Index 715-001 Conventional Lighting

**FY 2021-22
STANDARD PLANS**

CONVENTIONAL LIGHTING

INDEX 715-001	SHEET 1 of 3
-------------------------	------------------------

METAL POLE WIRING DETAIL

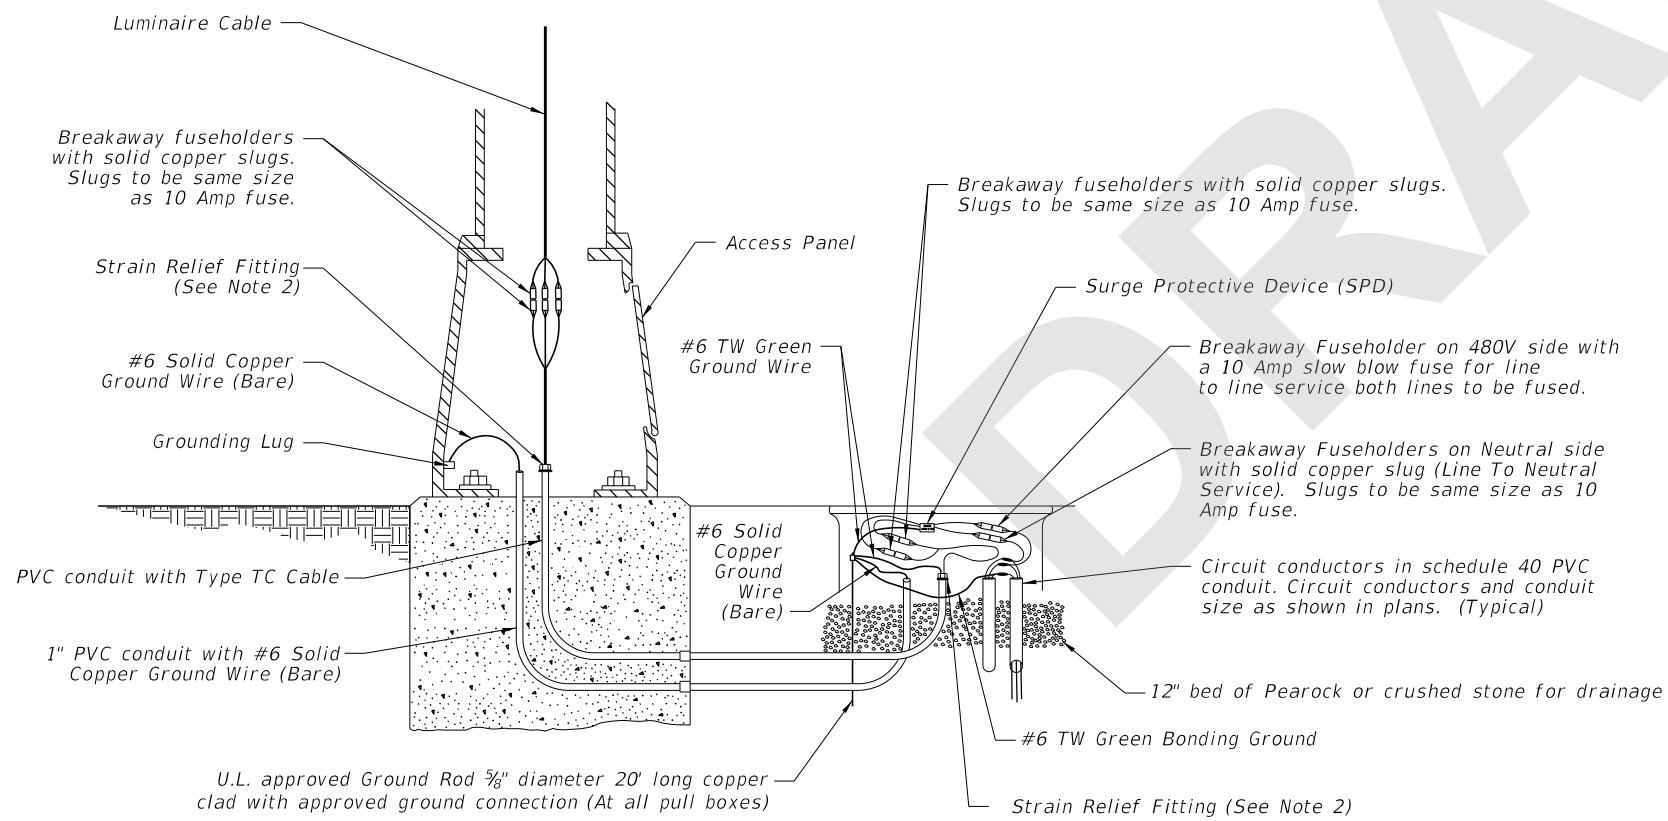
Sheet 1: Updated Note 1 for Concrete Barrier and bridge mount. Provided additional wiring detail, a reference to 715-002, and new information of where breakaway fuse holders fit inside of pole.

1. Concrete Barrier and Bridge Mounted Poles: Place wiring system following conduit layouts and requirements of Index 715-002. Follow additional requirements of Specification 992. For wiring and devices shown inside of pull boxes on this sheet, place inside of embedded junction boxes instead. Place the vertical breakaway fuseholders inside the pole, at the handhole location.

METAL POLE DETAIL

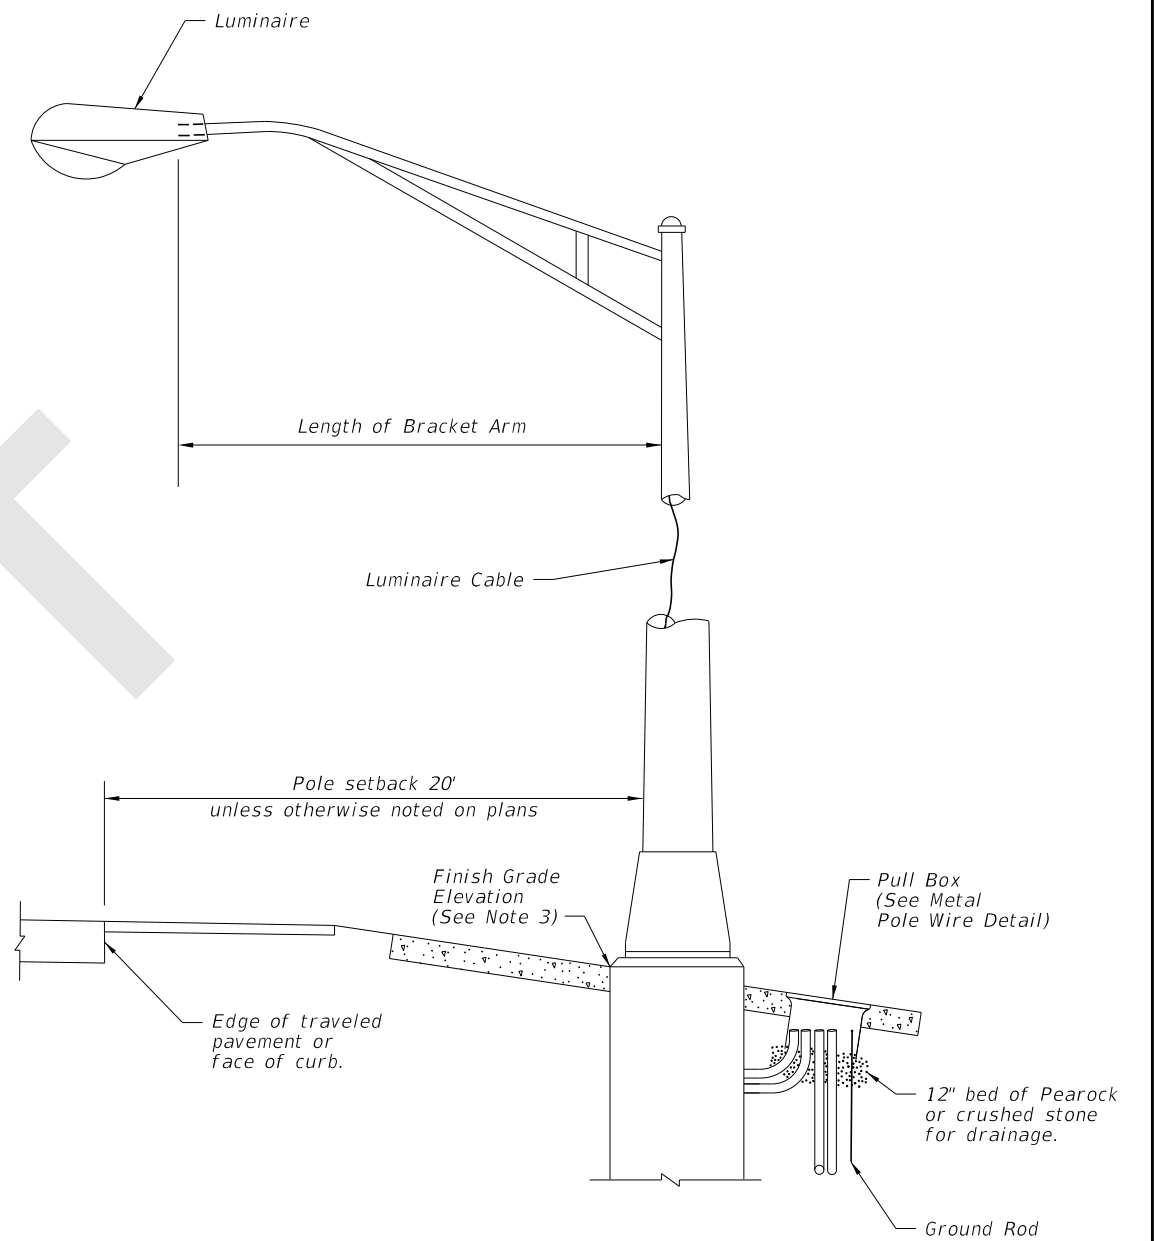
Added callout and new Note 3 to explain that the top of the concrete foundation is flush with the finish grade elevation on the side nearest to traffic lane. Added vertical tolerance.

COMMENT: Conventional lighting: Sheet 1 note 3 is confusing about the tolerance – Please clarify the -0 inch, + 2 inch.

COMMENT: Conventional lighting: Sheet 1 note 3 is confusing about the tolerance – Please clarify the -0 inch, + 2 inch.

RESPONSE: The vertical placement has zero negative tolerance below the nominal target, so the zero receives a negative sign. Based on feedback, this comment will be further clarified to specify that vertical refers to elevation, and the position on the foundation will be described to avoid dependence on the drawing's call-out reference.

Change made to Index: Note updated for clarity.

RESPONSE: The vertical placement has zero negative tolerance below the nominal target, so the zero receives a negative sign. Based on feedback, this comment will be further clarified to specify that vertical refers to elevation, and the position on the foundation will be described to avoid dependence on the drawing's call-out reference.

Change made to Index: Note updated for clarity.

3. Align the top, outside edge of the concrete foundation with the finish grade elevation on the side nearest the traffic lane. Relative to the finish grade elevation, this foundation alignment has a vertical tolerance of plus 2 inches to minus 0 inches.
